## ADDENDUM No. 1

### ITB No. 4669 - 2021 MISCELLANEOUS UTILITIES PROJECT

CITY OF ANN ARBOR - PUBLIC SERVICES - ENGINEERING  
2021 MISC. UTILITIES PROJECT  
LIBERTY STREET TYPICAL SECTIONS

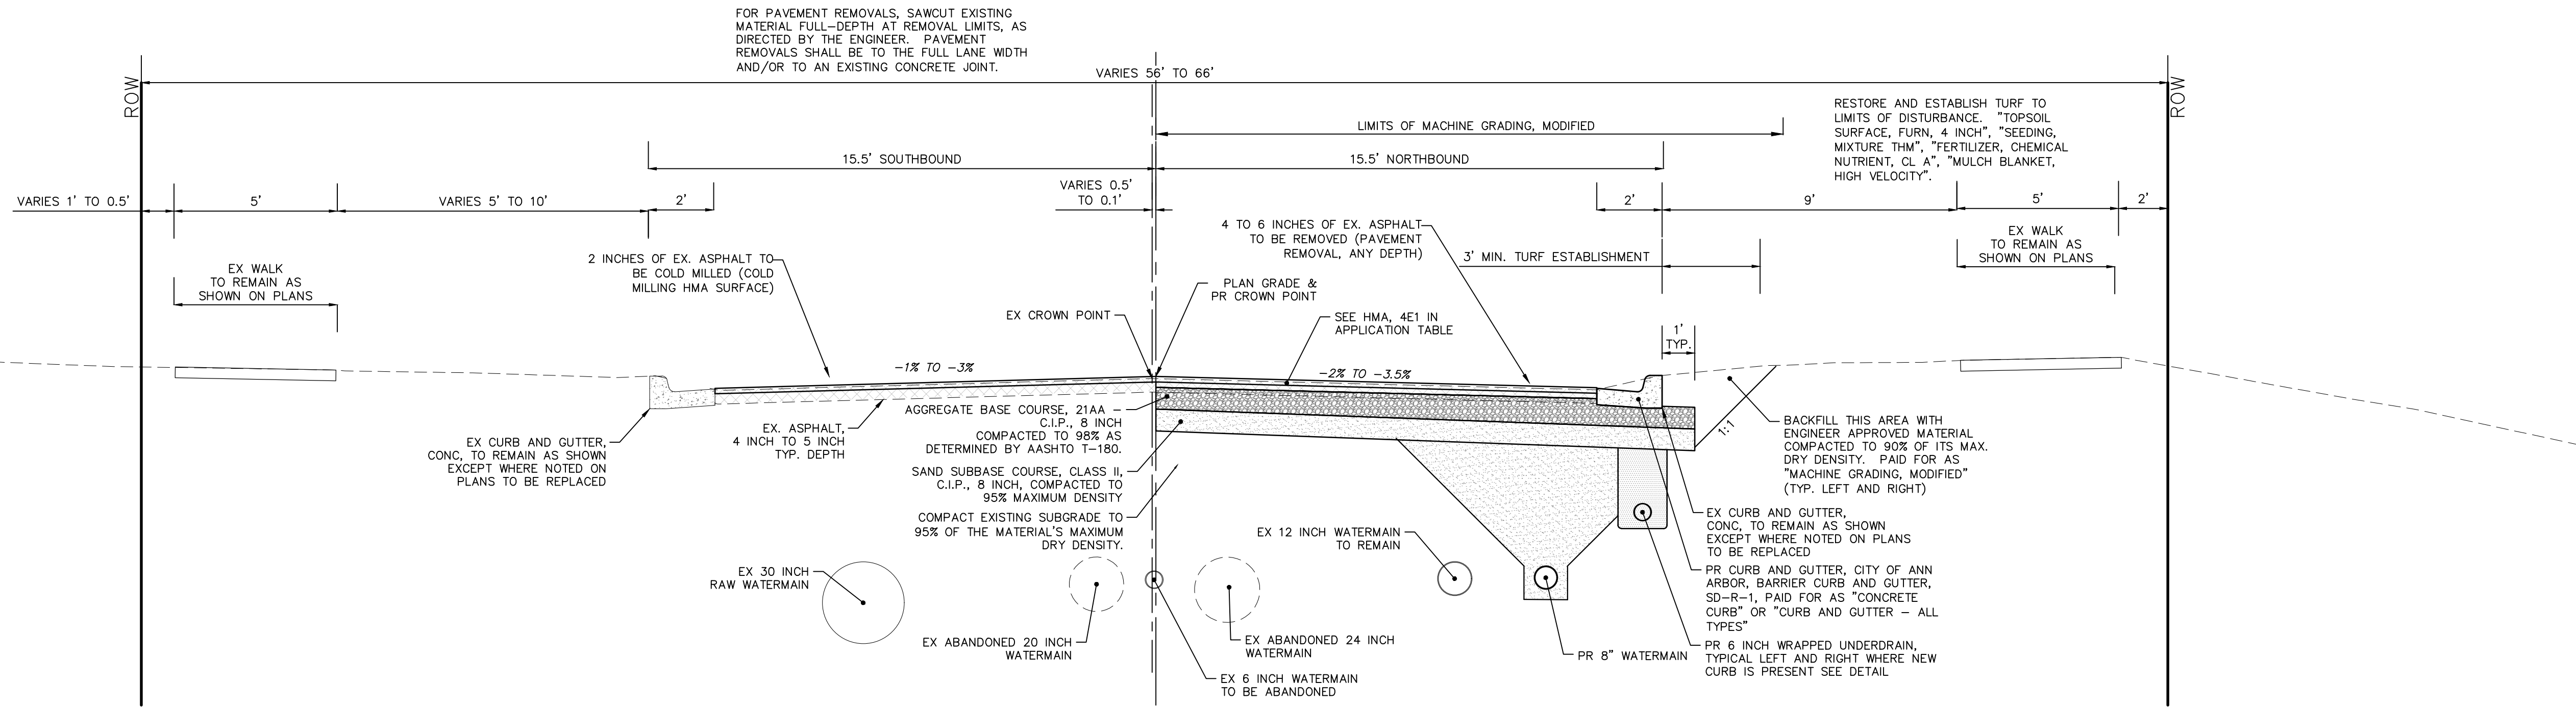
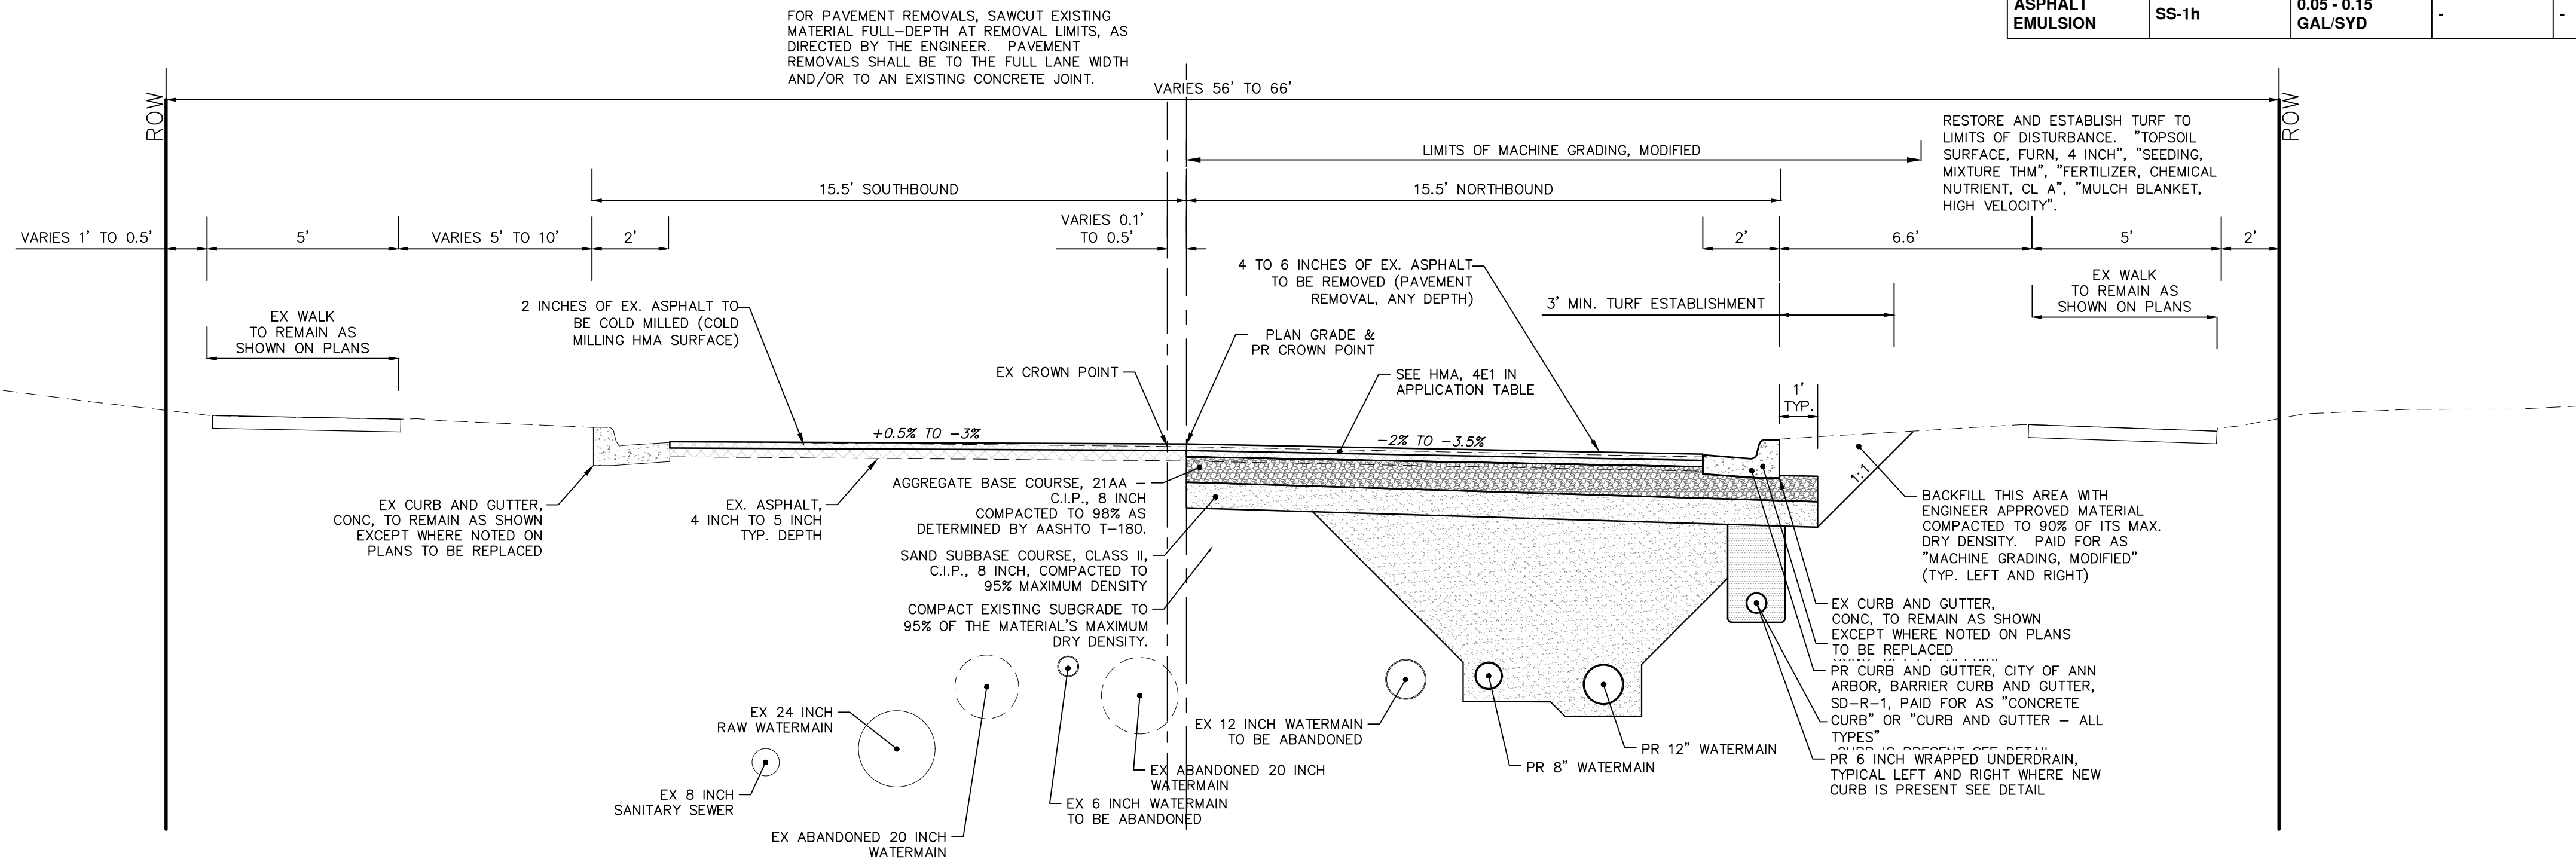
Answer 8: Pay Items 701 thru 703 have been added for soil erosion control pay items.
- Question 9: Please detail how the AREA for "Machine Grading" will be calculated. The specifications are silent as to how the transverse / longitudinal limits are to be determined.

Answer 9: Machine grading limits are calculated to the edge of the 1:1 slope outside of road grading as indicated in the street proposed typical sections on Sheets 4 thru 7. Additional clarification has been added to the Machine Grading specification section.

**PRESSURE REDUCING VAULT**  
PLAN VIEW - NOT TO SCALE

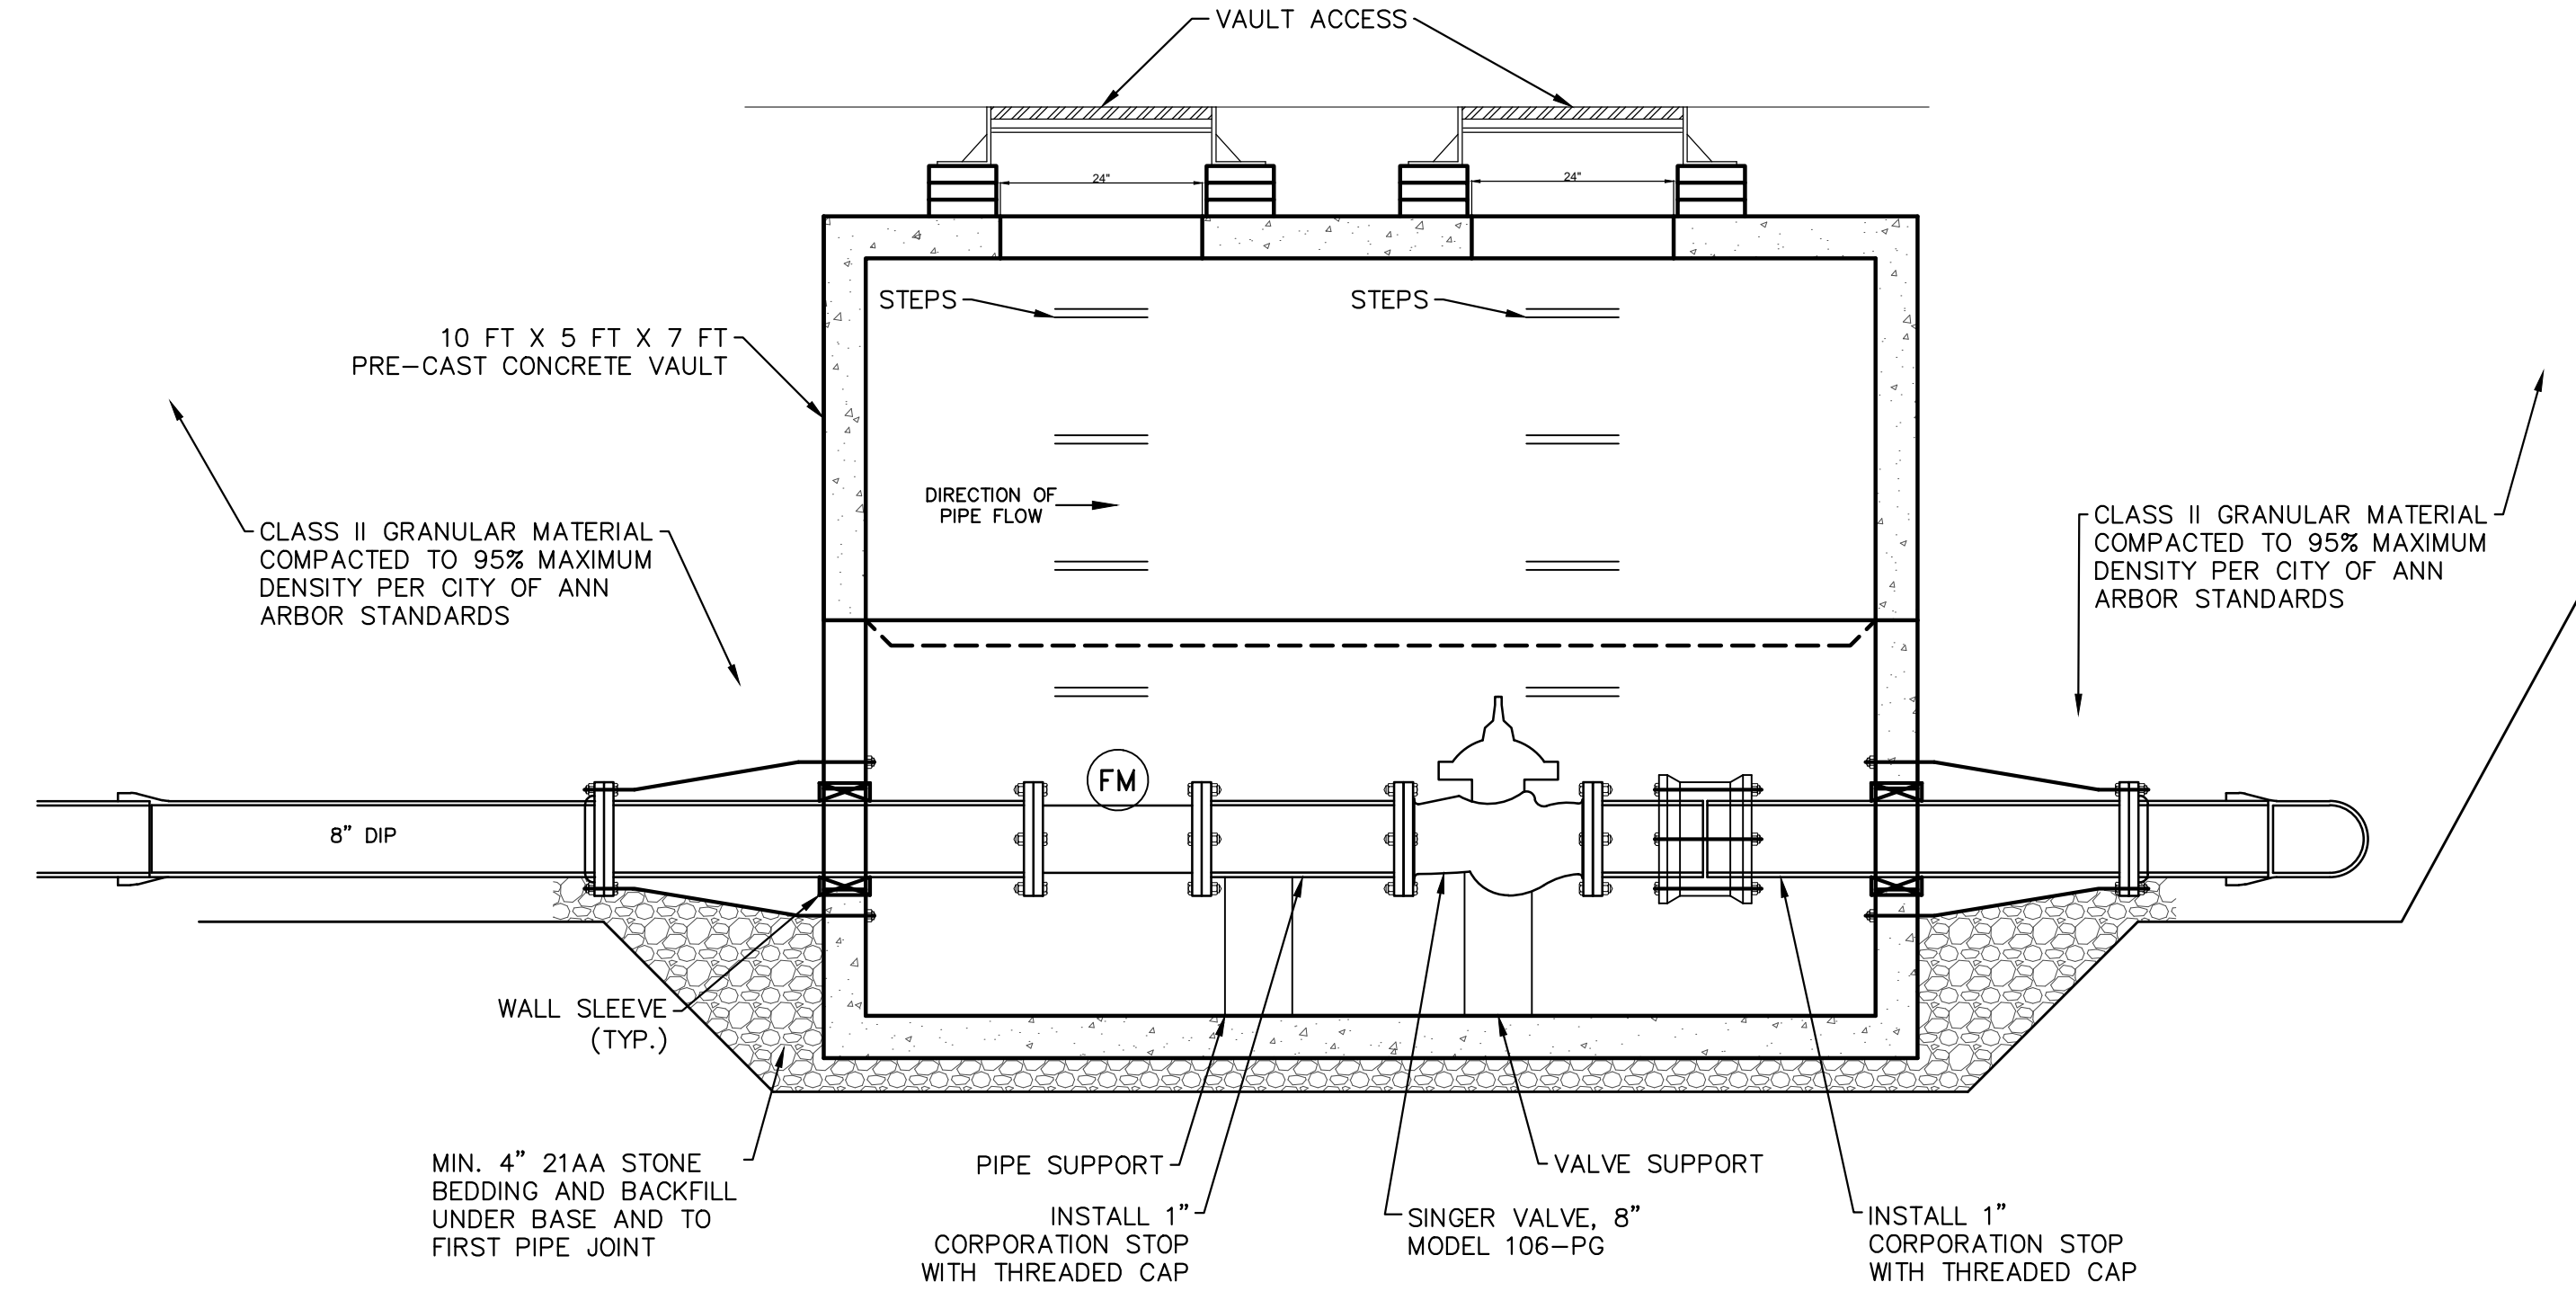
Answer 10: Pavement removal and/or machine grading will be paid for separately.
- Question 11: There is no SP for pay items 228 [Abandon Vault (PRV)] and 450 [72" x 96" Conc Vault (PRV)]. In addition, plan details are very limited and the scope of work for these items is not well defined. Please provide additional information as necessary.

Answer 11: An "Abandon Vault (PRV)" detailed specification has been added and renumbered 224. A "60" x 120" Concrete Vault (PRV)" detailed specification has been added.
